Addendum No. 3

Re: Mobile Alabama Cruise Terminal
Parking Deck Repairs
Project #CT-009-24

Date: February 20, 2025

3rd LEVEL PARKING DECK REPAIR PLAN
 SCALE: 1/16"=1'-0"

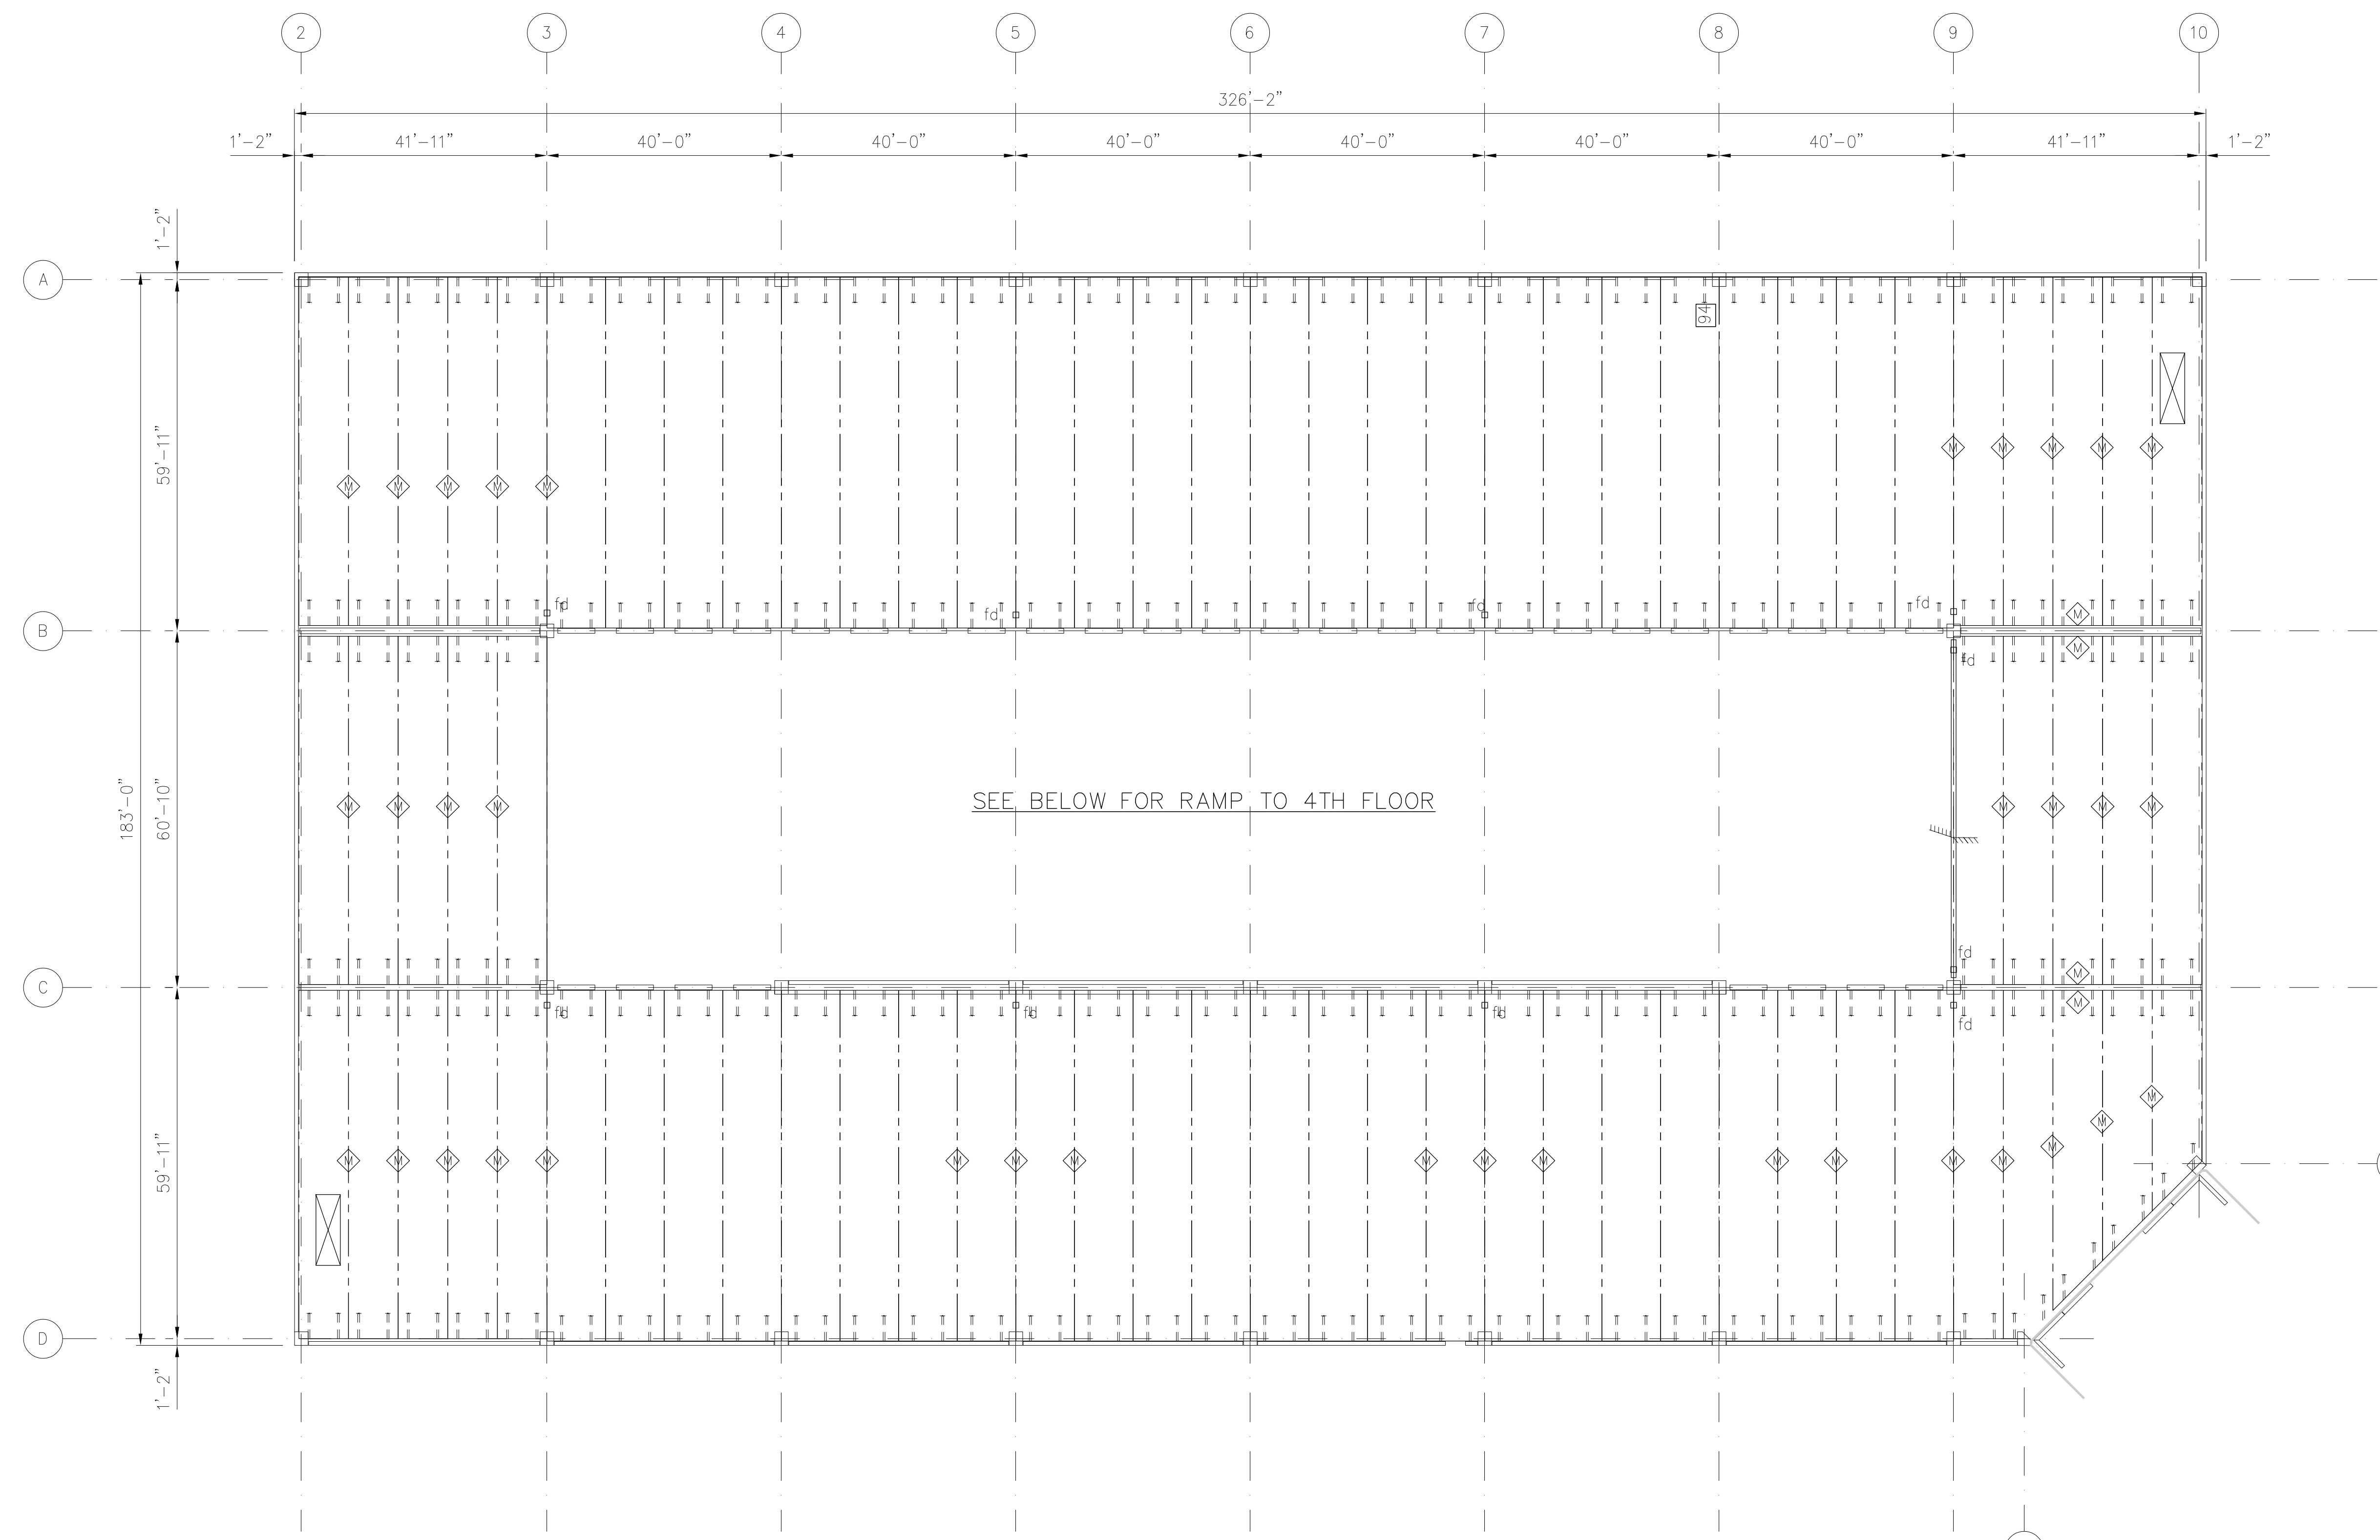
S1.3 3rd Level Repair Plan

Item 1 Coordinated Scope of Work Alternate: Changed label to Alternate #1 in note near Title Block.

SHEET TITLE: **4TH LEVEL REPAIR PLAN**

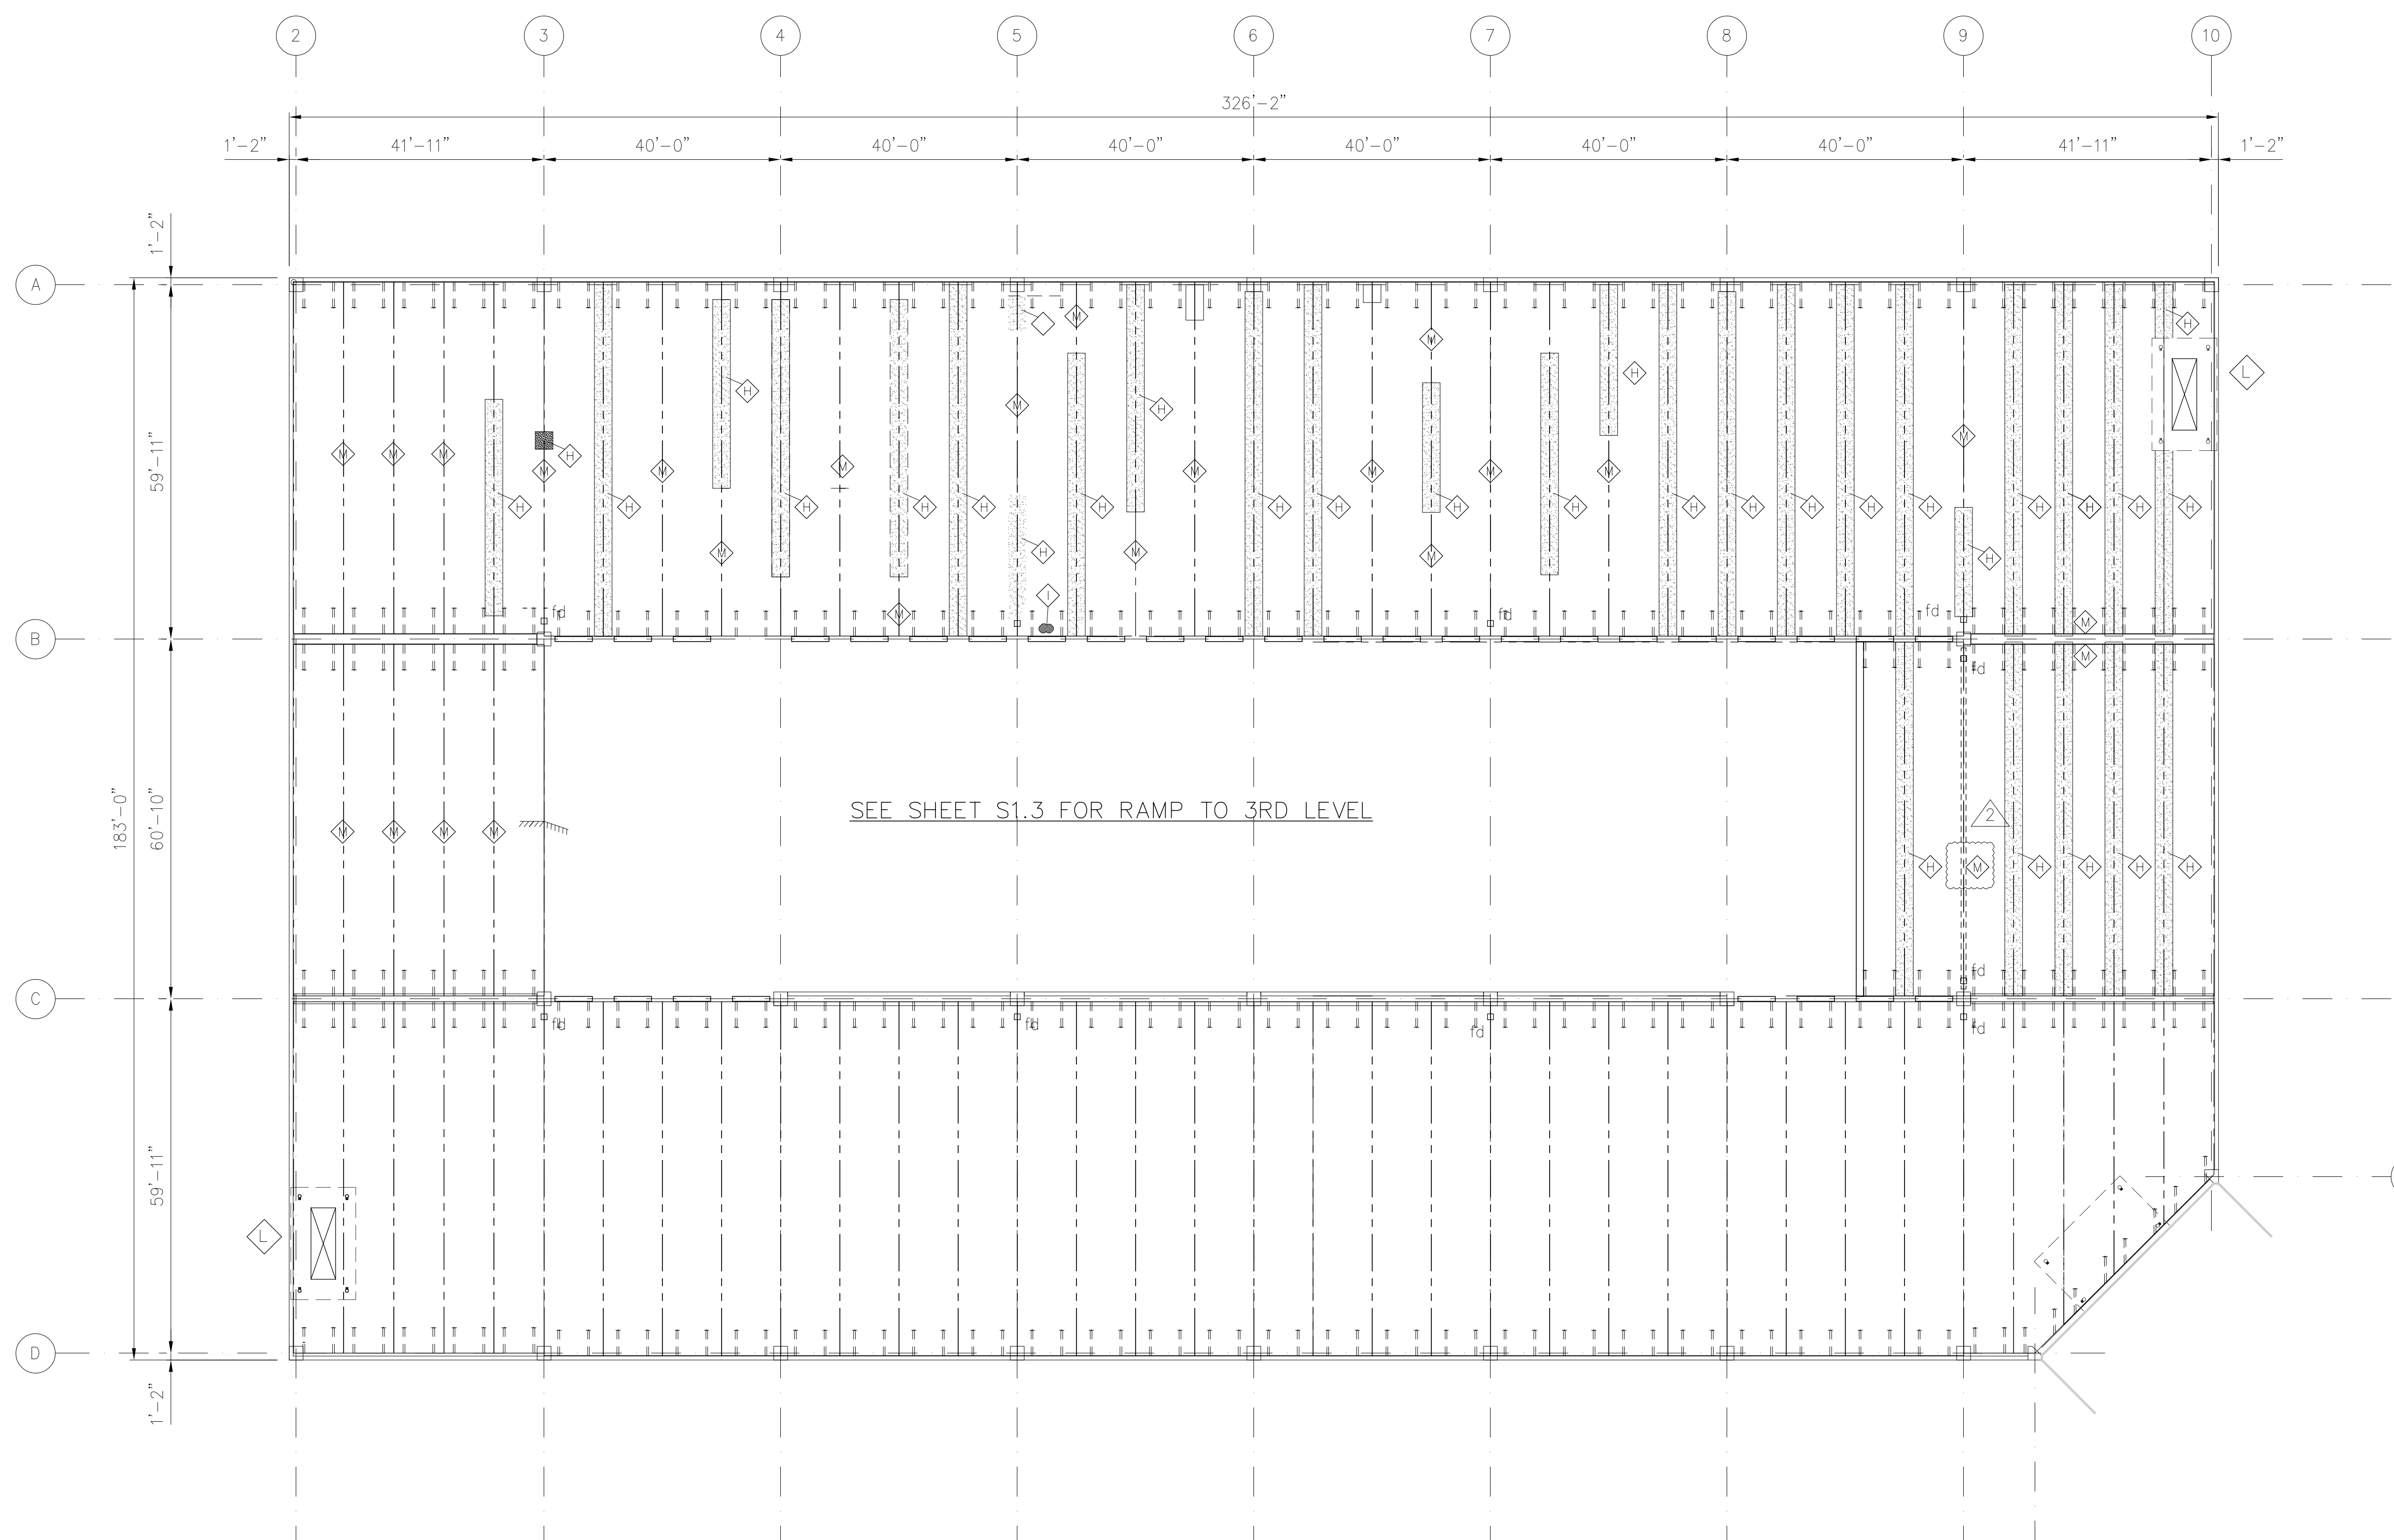
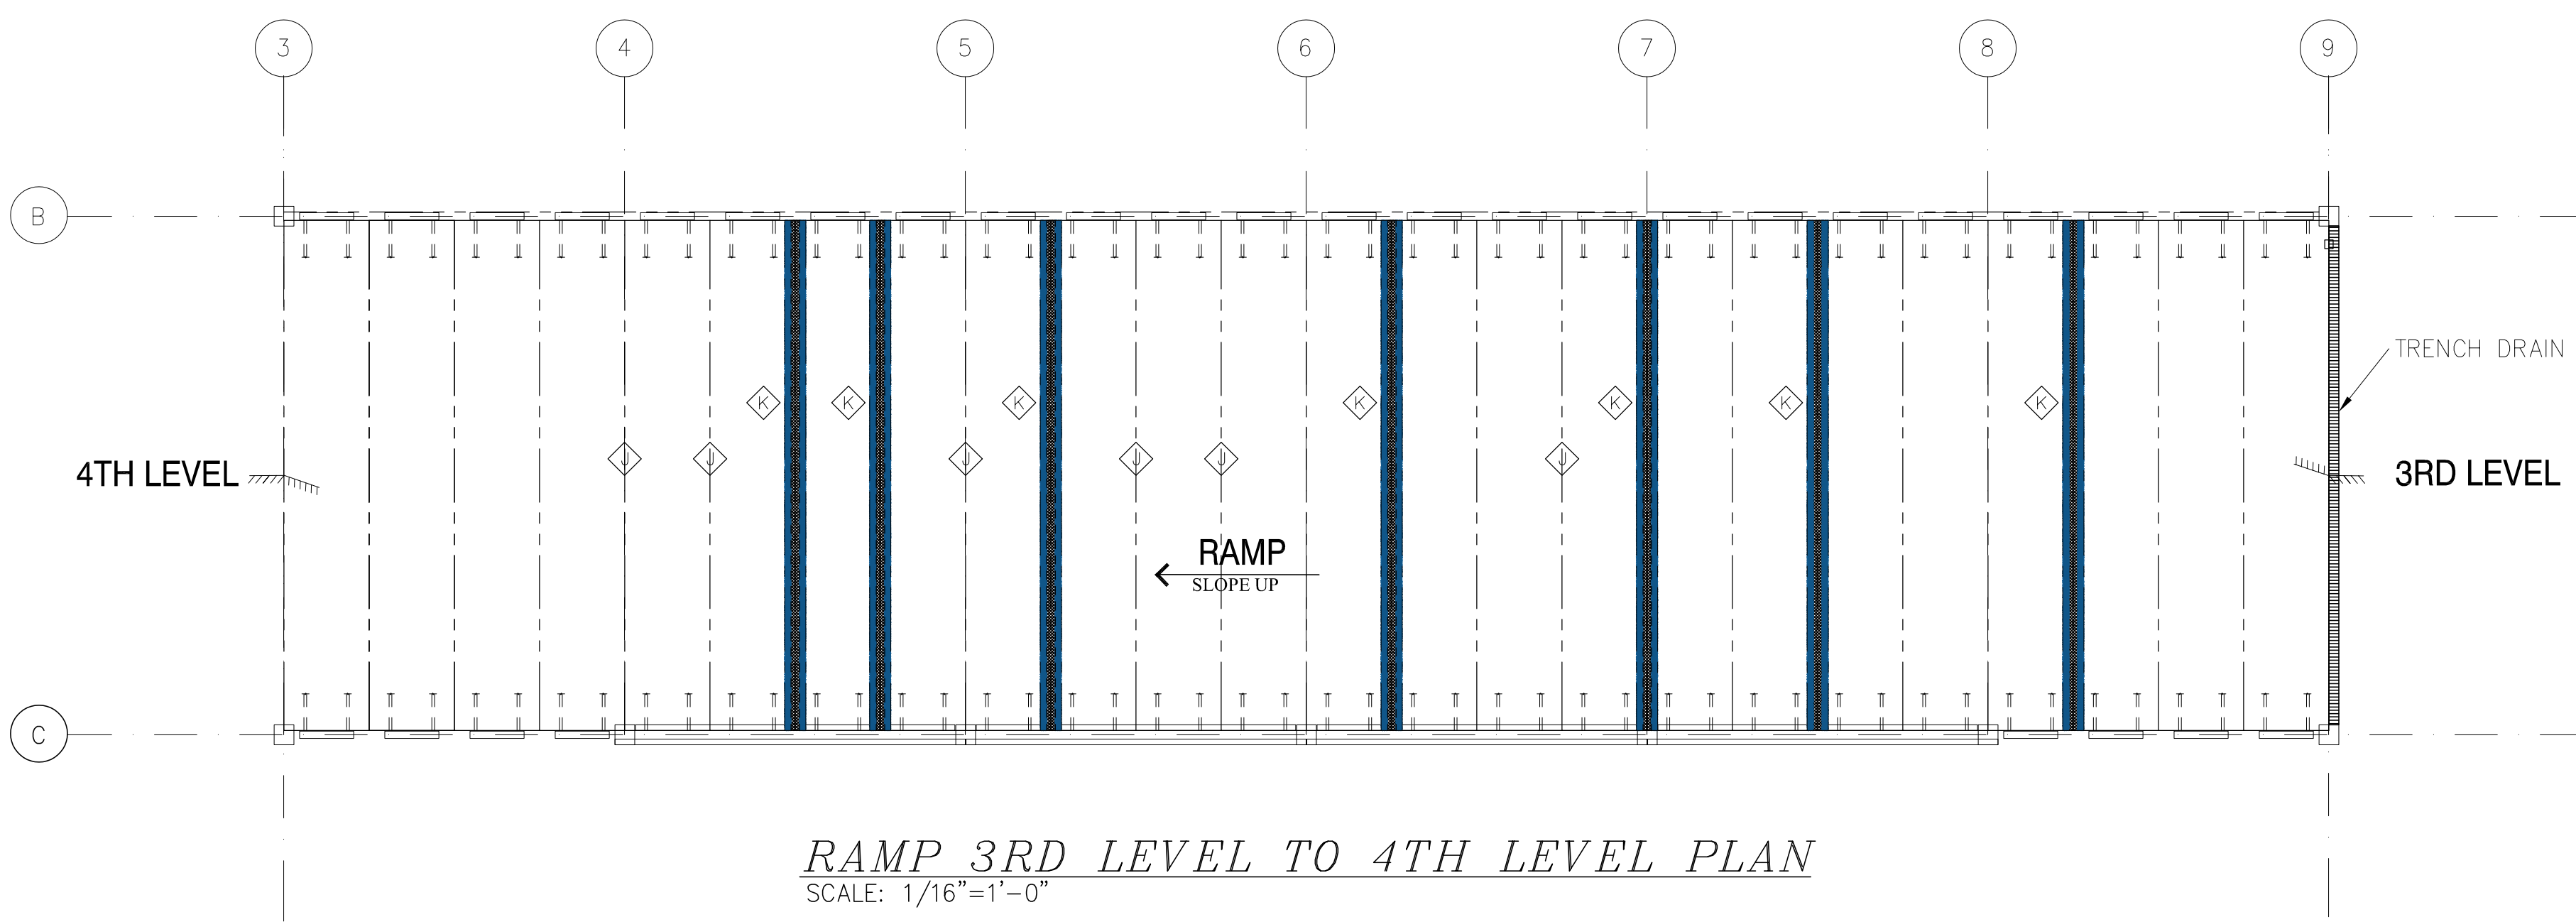
S1.4 4th Level Repair Plan

Item 1 Right hand side of page, remove Keynote M from the Issue for Bid set and replace with Keynote M clouded and flagged as Revision #2.

Item 2 On drawing "4th Level Parking Deck Repairs" added a keynote M in new location as clouded as Revision #2.

Question 3: Shaded Joints”H” on page S1.4 are marked on both sides of the original joint. Can you confirm that we are to cut out BOTH sides of the joint where shaded?

- Question 7: Plan Sheet S1.4, Column Line 9, between B & C – This area is labelled as type “M” joint repair – There is no existing joint in the topping slab at this location. Only a crack. Please advise on repair procedure.

Answer: The work should be within the cracks. If the crack is on one side only of the joint, then the repairs would be primarily on that side with the only work on the other side being that which is required straighten out the join and repair any fractured material.

- Answer: Revised drawing S1.4 should eliminate confusion.
- Question 8: At the Pre-Bid, it was discussed that the photo report that accompanies the drawings should be used as the basis for determining quantities. However, this is very subjective, and as with all concrete repair, the actual spalled material varies & is technically “concealed” or unknown until demolition occurs. Crack repair start & end points are somewhat subjective as well. With quantities of each being left up to interpretation, there is no way for Contractors to truly bid apples to apples for these scope items. Request for Allowances to be established for Base Bid purposes (along with current allowances & unit prices).
